COUNCIL REPORT

Date:	May 2, 2024
From:	Hanna Demyk, Planning Technician
Subject:	Proposed Development Permit with Variances at 2368 Bellevue Avenue
File:	1010-20-23-079

THAT the applicant for the proposed “Development Permit No. 23-079” for 2368 Bellevue Avenue be directed to revise their application to respond to staff advice as outlined in the report dated May 2, 2024.

Figure 2 – Site plan showing proposed development.

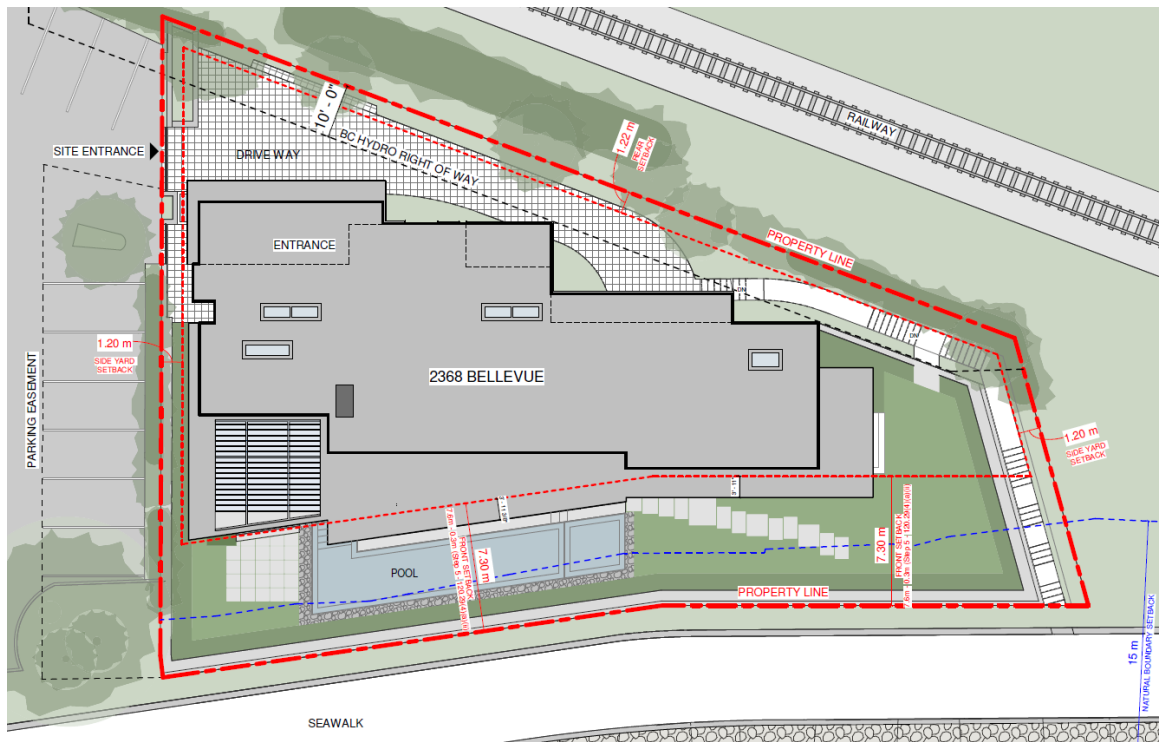
The proposal also includes new retaining walls along the south, west, and east of the subject site (**Schedule A of Appendix A**). The retaining walls are proposed to be constructed adjacent to property lines, allowing for additional yard space to the south of the site where a pool, hot tub, and covered patio spaces are proposed (Figure 4).

Figure 4 – Section showing proposed retaining wall to the south of the site adjacent to the Centennial Seawalk.

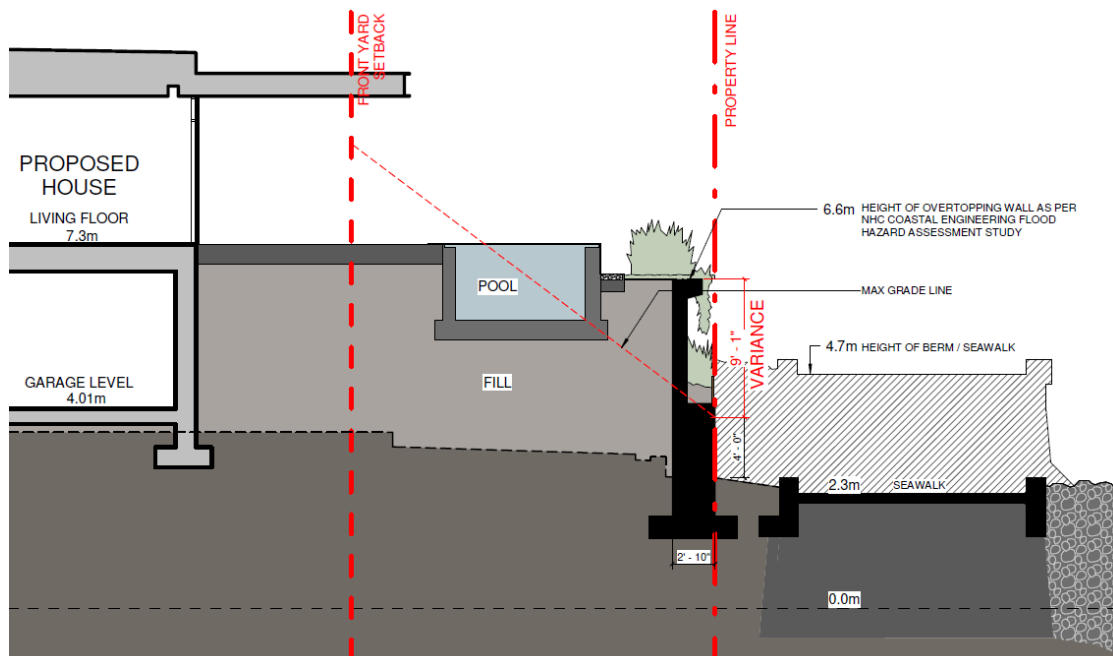
The applicant proposes zoning bylaw variances to retaining wall height and grade line angle as per proposed plans and outlined below (Figure 5). In general, the maximum permitted height of a retaining wall adjacent to a property line is 1.2 m. The retaining wall along the south property line is

proposed to be 4.1 m in height, 2.9 m taller than permitted in the zoning bylaw. The retaining wall along the west property line is proposed to be 2.3 m in height, 2.1 m taller than permitted in the zoning bylaw. The proposed retaining wall to the east of the site complies with zoning regulations adjacent to the property line but requires a variance to the required grade line angle. Overall, this would result in a significantly higher wall located adjacent to the Centennial Seawalk than would otherwise be permitted as shown in Figure 4.

- a. Revise the proposal to include additional stepped retaining walls in compliance with retaining wall and grade line requirements of the Zoning Bylaw, moving site protection away from the seawalk/public realm; or
- b. push the proposed raised retaining wall further behind the property line to provide additional landscaping and buffering between the private and public realm.
